# Monthly Specification Update

***Intel® Server Board S5000PAL***

*Intel Order Number D65289-035*

**February 2011**

## 1. The SMBUS block diagram (Figure #16) provided in Rev. 1.1 of the Intel® Server Board S5000PAL/S5000XAL TPS requires changes to accurately reflect production hardware design

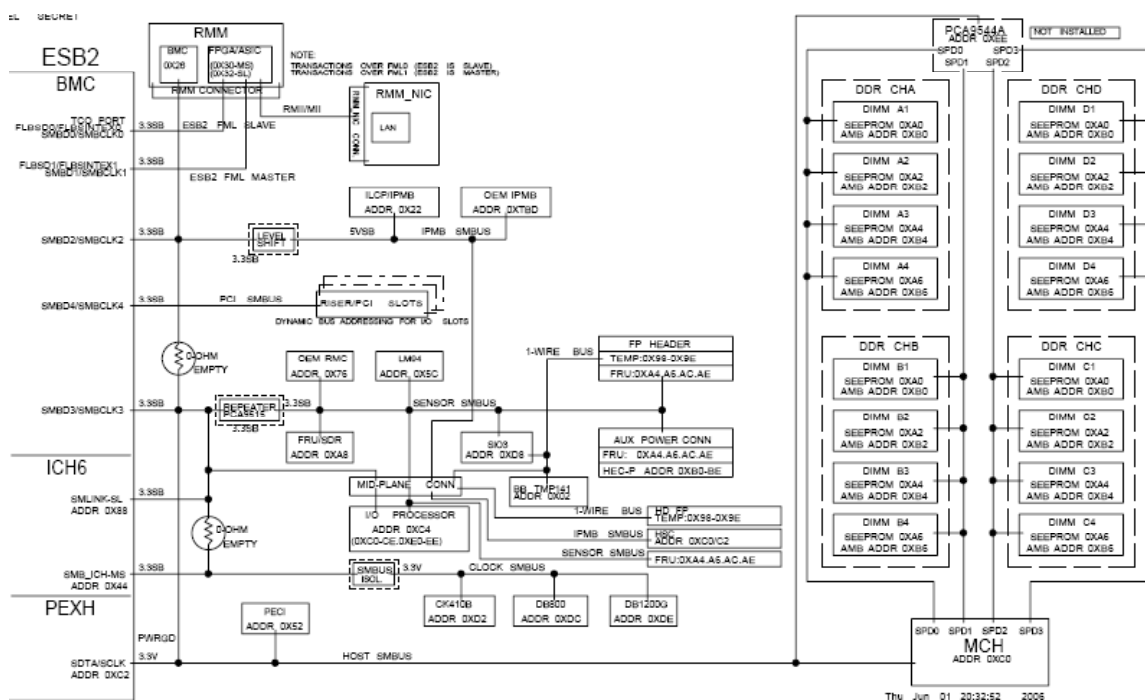
- Add PECI controller
- Remove separate HSC connector
- Correct Midplane -> FP SMBus connections and 1-wire temp sensor
- Correct SMBus and 1-wire temp sensor connections to FP connector
- Correct FBDIMM labeling

The corrected diagram is shown:

## 2. The power block diagram (Figure #25) as provided in Rev. 1.1 of the Intel® Server Board S5000PAL/S5000XAL TPS does not reflect the final, production-level baseboard design

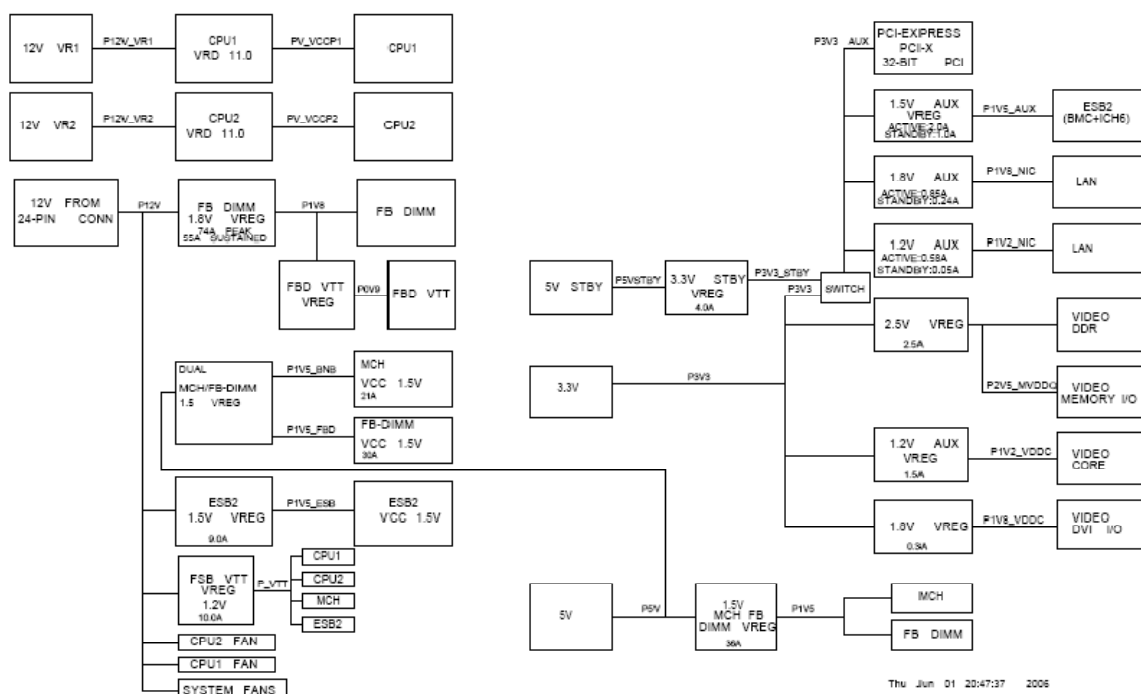
- MCH/FBDIMM 1.5 Vreg moved from 12 V rail to 5 V rail.
- Video Memory Vreg corrected to only one 2.5 V reg. instead of two.
- “ATI” label for Video components changed to generic “Video”.

The corrected diagram is shown:

**Figure 22. SAS/SAS RAID Mid-plane Board**

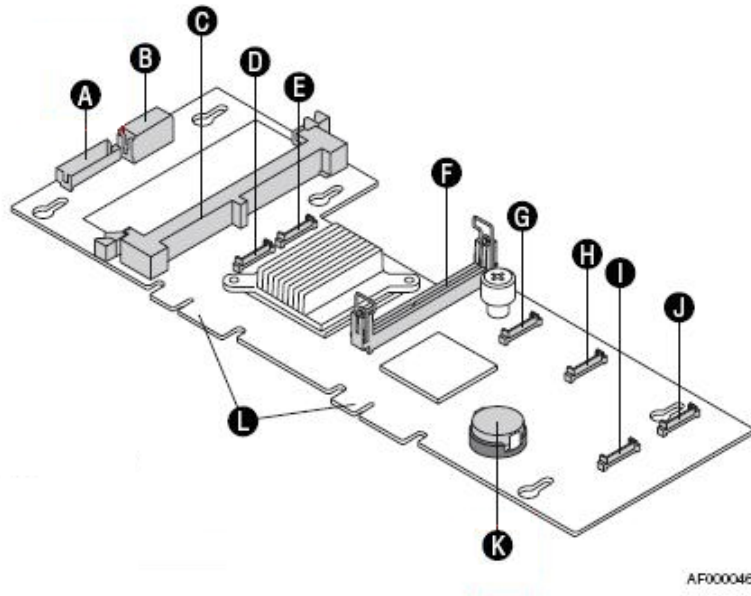
**3. SAS/SAS RAID midplane board (Figure #22) as provided in Rev.1.0 of the Intel® Server System SR2500AL TPS should swap the descriptions of items A and K**

Implication: This is a typo.
